ADDENDUM 1 – JOB 22207

TO: All prospective bidders on Projects NH-SS-1-006(025)022, Job No. 22207 scheduled for the February 11, 2022 bid opening.

PROJECT INFORMATION		
Project:	NH-SS-1-006(025)022	PCN: 22207
Location:	ND 6, JCT BIA 7 to JCT ND 21	
Date:	2/8/2022	Lead Designer: Jonathan P Morgenroth, PE
Bid Opening Date:	2/11/2022	JOB#: 22207 Addendum#: 1

Sliver Grading, Subcuts, Pipe Extensions, Pipe Replacement, Pipe Rehabilitation,
Structure Replacement, Foam Jacking, Milling & RAP Overlay

Revised	2/4/2022	STATE	PROJECT NO.	SECTION NO.	SHEET NO.
		ND	NH-SS-1-006(025)022	30	3

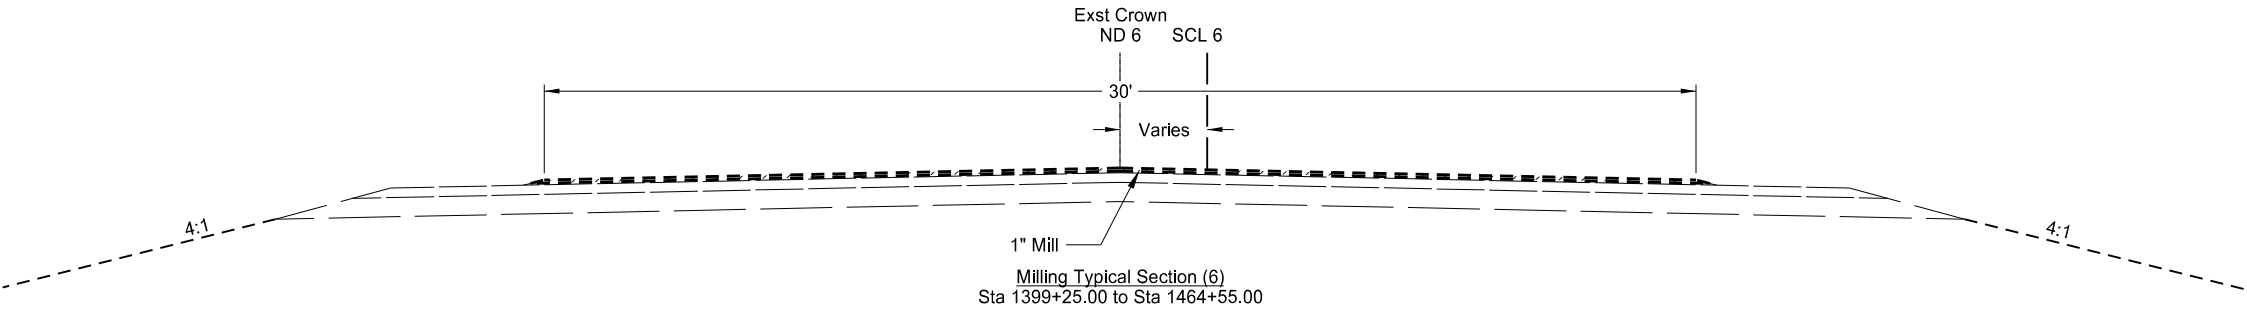
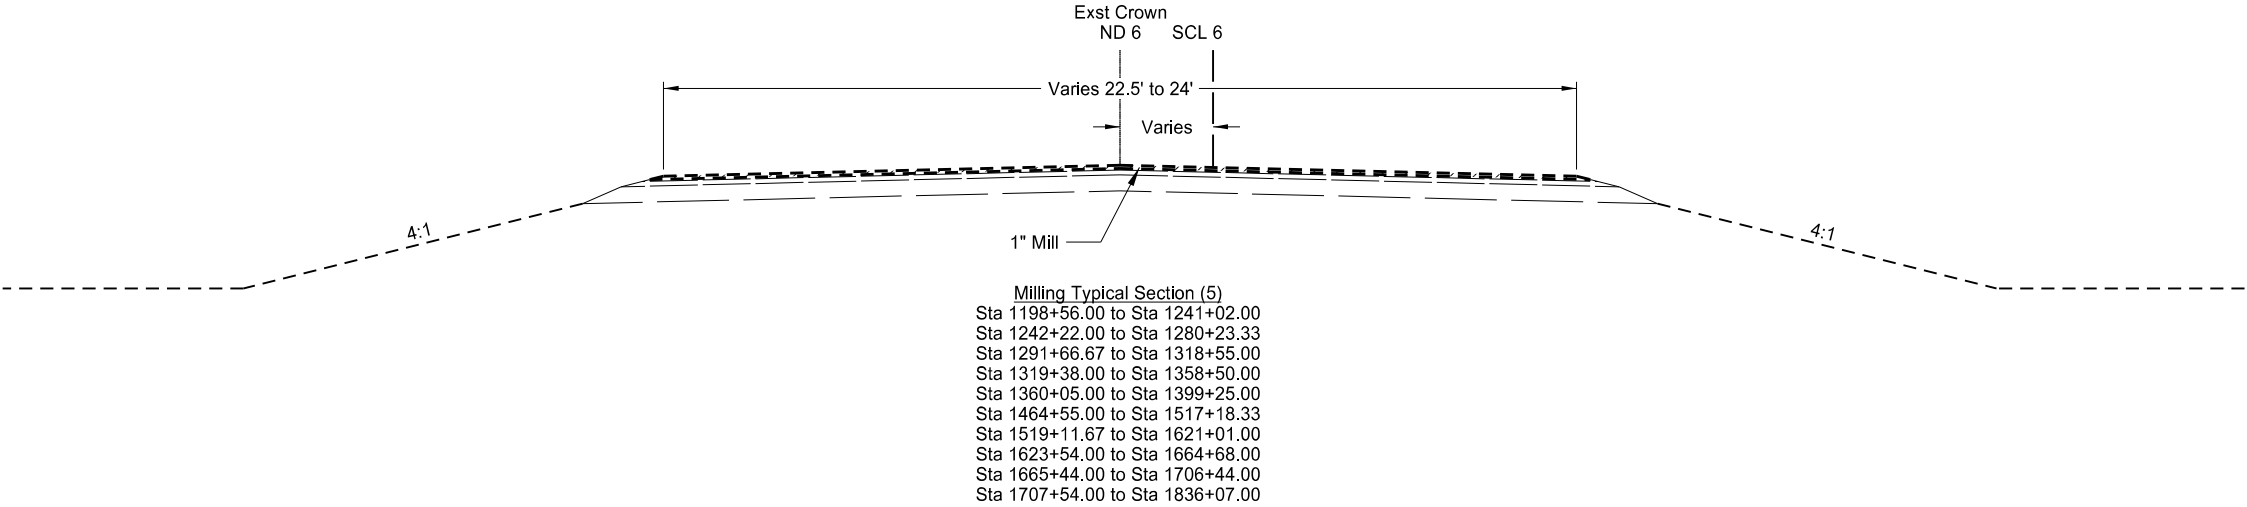
8	3	Revised quantity for 764 0131 "W-Beam Guardrail" from 1604.6 LF to 740.2 LF Revised quantity for 764 0145 "W-Beam Guardrail End Terminal" from 16 EA to 8 EA Revised quantity for 764 0151 "Remove W-Beam Guardrail & Posts" from 313 LF to 0 LF Revised quantity for 764 2080 "Remove Box Beam Guardrail" from 1168 LF to 584 TON
10	1	Updated Paving Table and Qtys
10	2	Updated Water Table and Qty
30	3	Updated Stations on Top Typical Section
30	5	Updated Stations on Top Typical Section

Revised	2/4/2022	STATE	PROJECT NO.	SECTION NO.	SHEET NO.
		ND	NH-SS-1-006(025)022	30	7

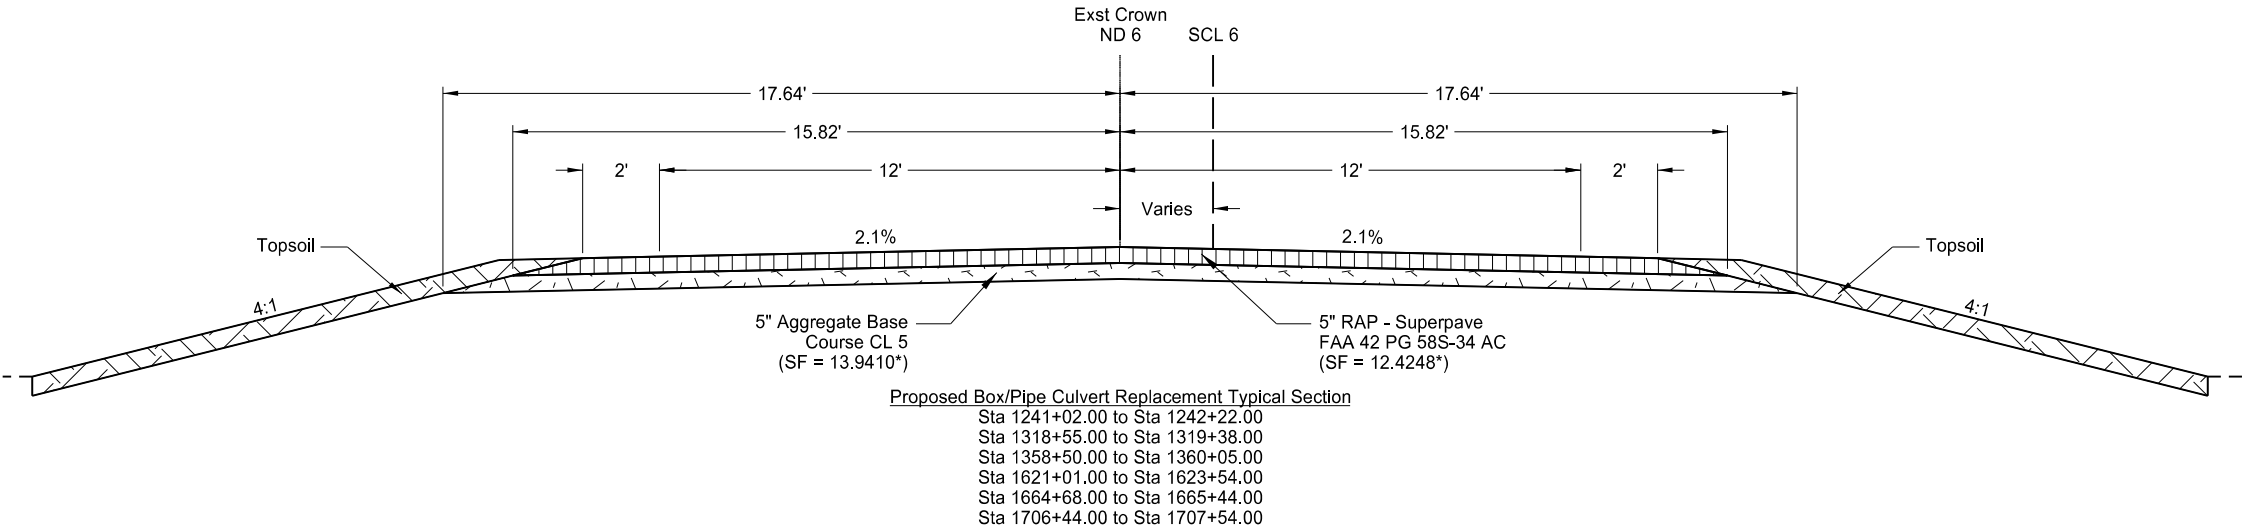
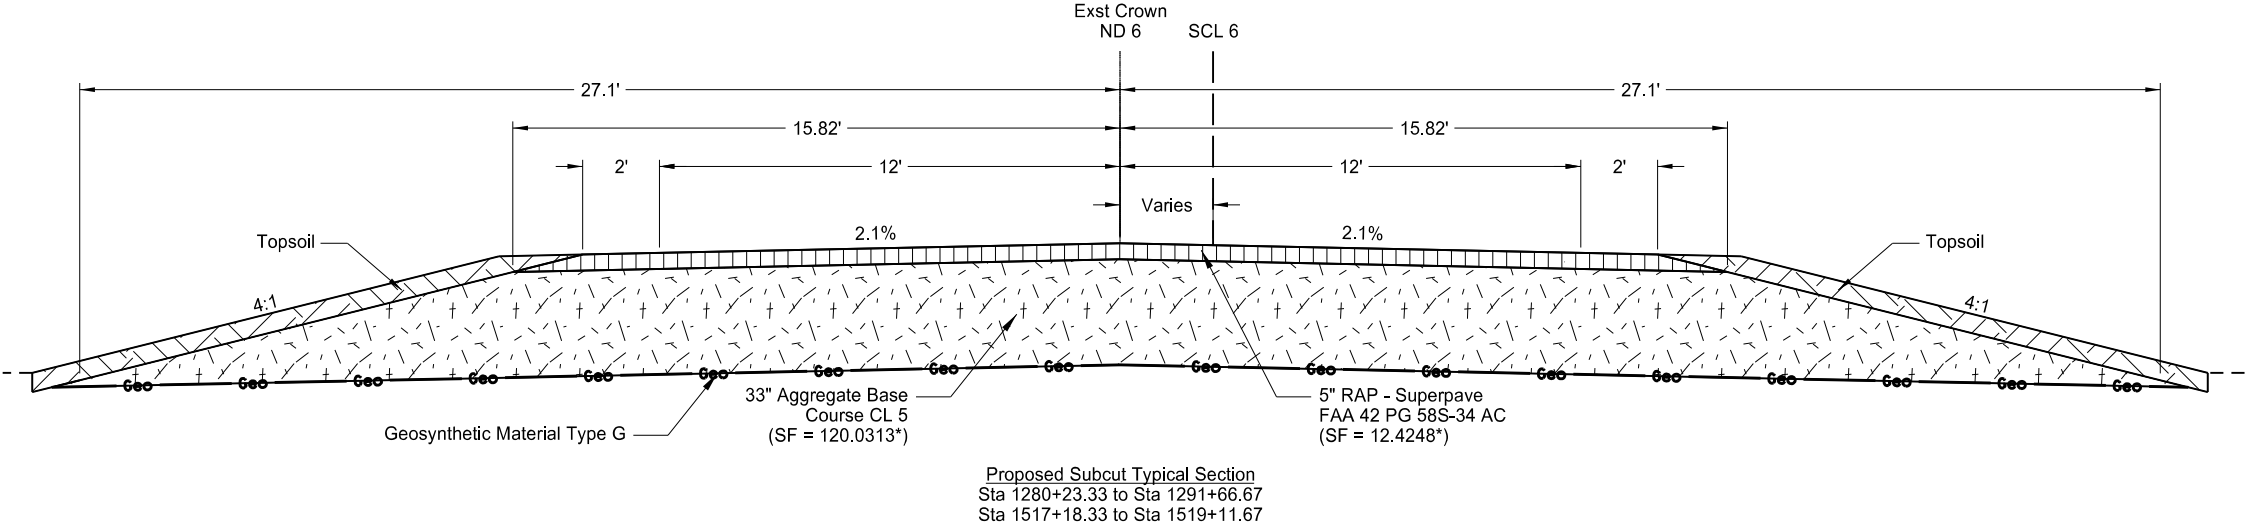
30	7	Updated Stations on Bottom Typical Section
170	1	Updated Approach Slab length in Plan view Changed cross slope requirement in Note. Updated curb line work and existing steel callout in Barrier End Modification Detail. Relocated bar labels in End View for clarity. Corrected Approach Slab Stationing.
170	2	Revised Note 748 CURB. Relocated Note 930 SILICONE SEALANT and Note 930 BARRIER END MODIFICATION from Sheet 3. Relocated and modified Note 930 POLYURETHANE FOAM to Sheet 3.
170	3	Relocated Note 930 SILICONE SEALANT and Note 930 BARRIER END MODIFICATION to Sheet 2. Relocated and modified Note 930 POLYURETHANE FOAM to Sheet 3.
170	4	Corrected Exiting Cur Plan and Existing Curb Elevation details. Provided additional dimensions for curb in Proposed Elevation
170	5	Revised quantity for 602 1131 "Class AE-3 Concrete-Box Culvert" from 60.2 CY to 60.0 CY. Revised quantity for 612 0114 "Reinforcing Steel-Grade 60-Box Culvert" from 7,509 lbs to 7,373 lbs.

Revised	01/21/22	STATE	PROJECT NUMBER	SECTION NO.	SHEET NO.
		ND	NH-SS-1-006(025)022	170	8

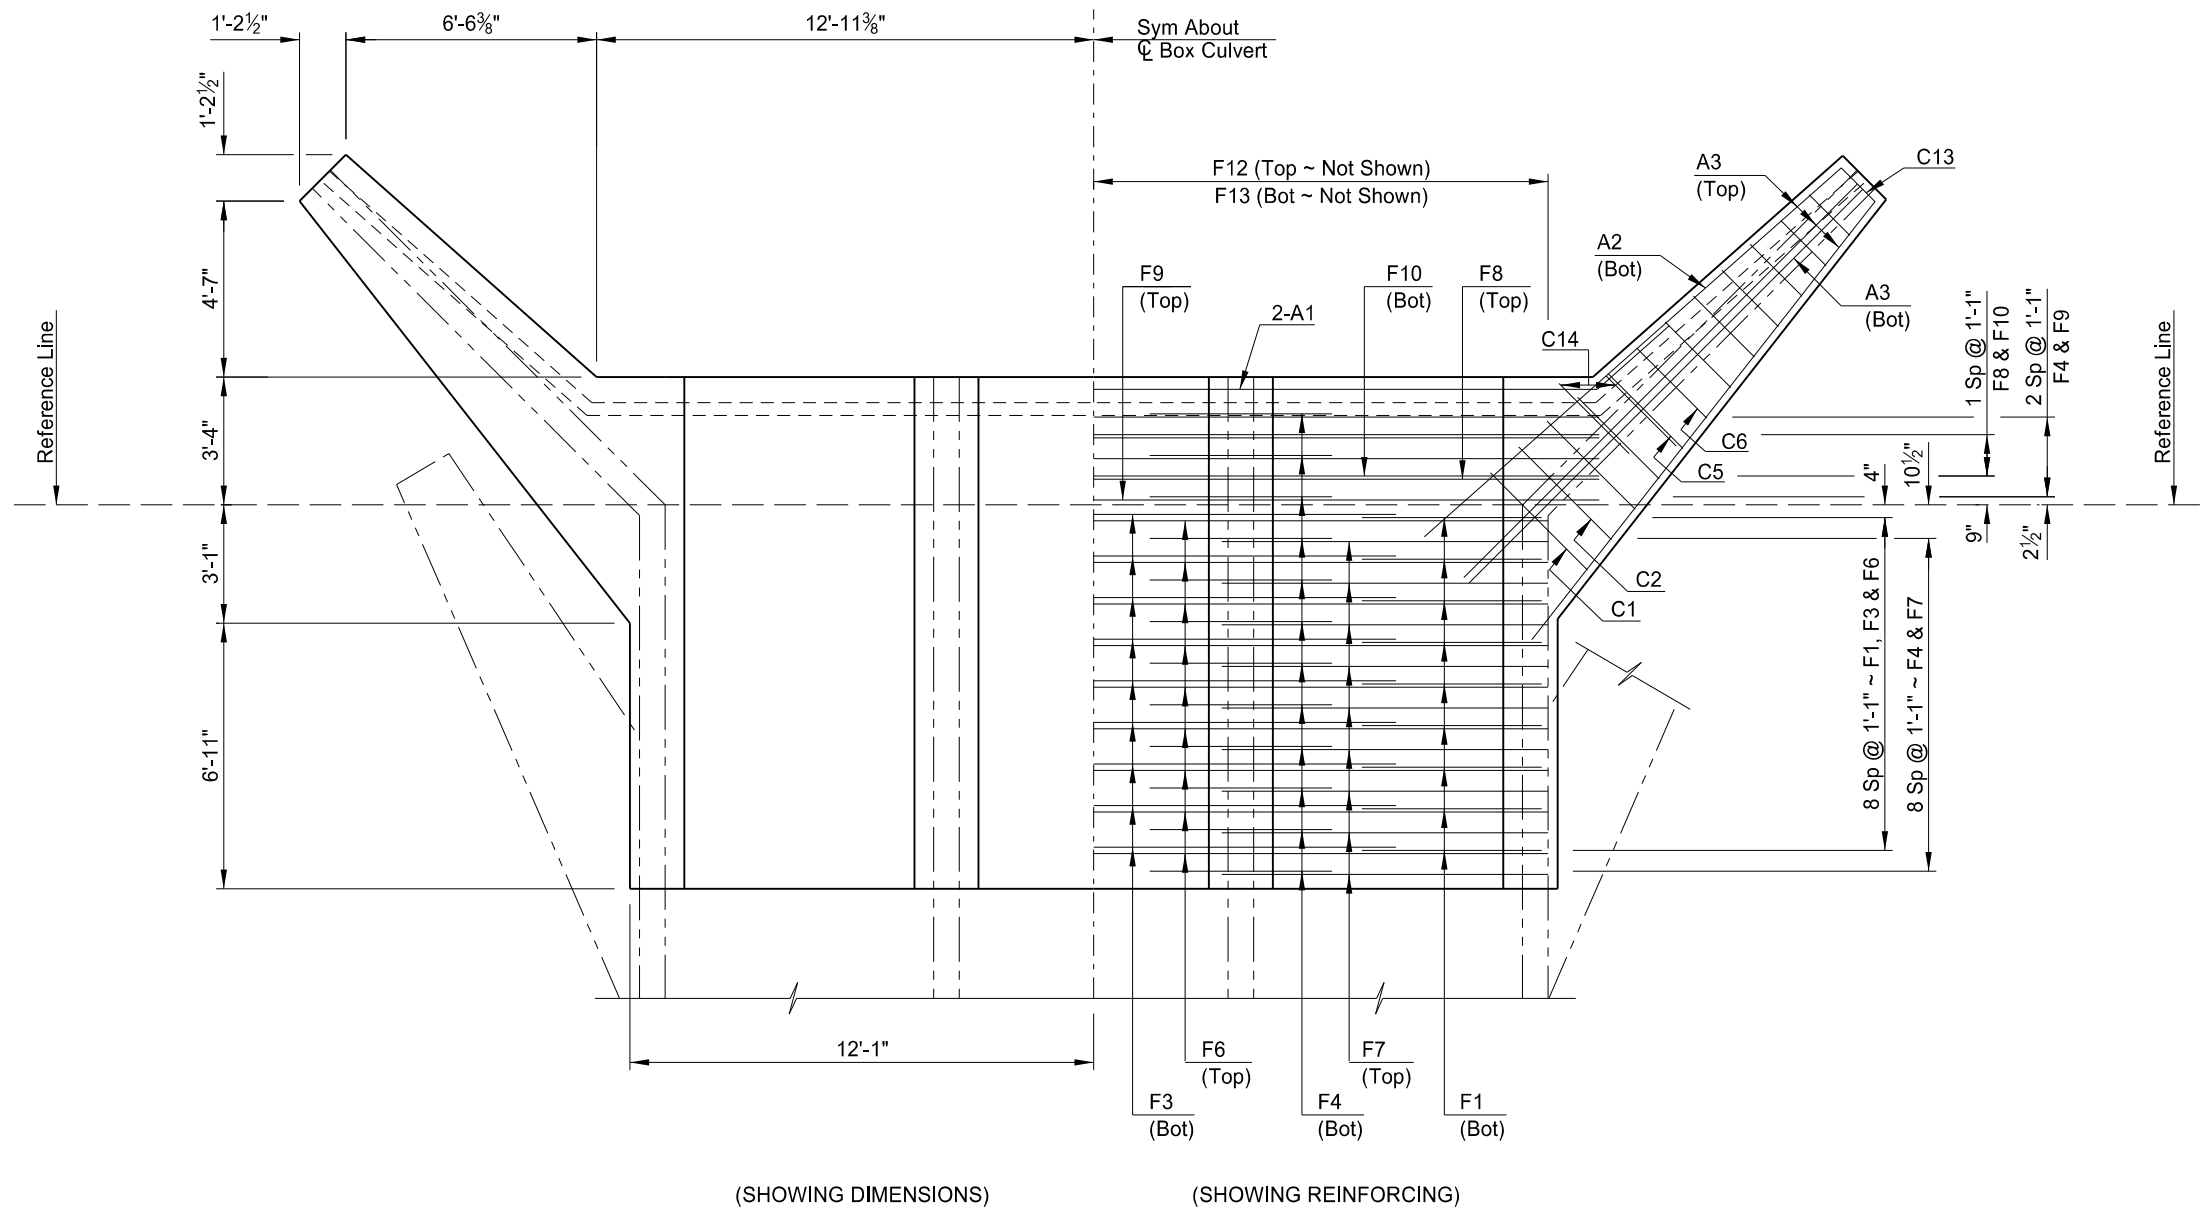
170	8	Revised callout for F12 and F13 bars.
170	9	Removed P3 bars from both sections. Added 1 V1 bar in the Outer Wall section.
170	11	Revised details for the following bars: H4, H5, V1, V5, F4, TE Revised concrete quantities. Revised quantity table.
170	13	Reissued for signature.
170	16	Modified 5XC500 Bar Detail Updated existing in place reinforcing and 4XA500 bar labels in Barrier End Modification Detail.
180	1	Added Pit Plat to the project
180	2-4	Added Boring Logs to the project
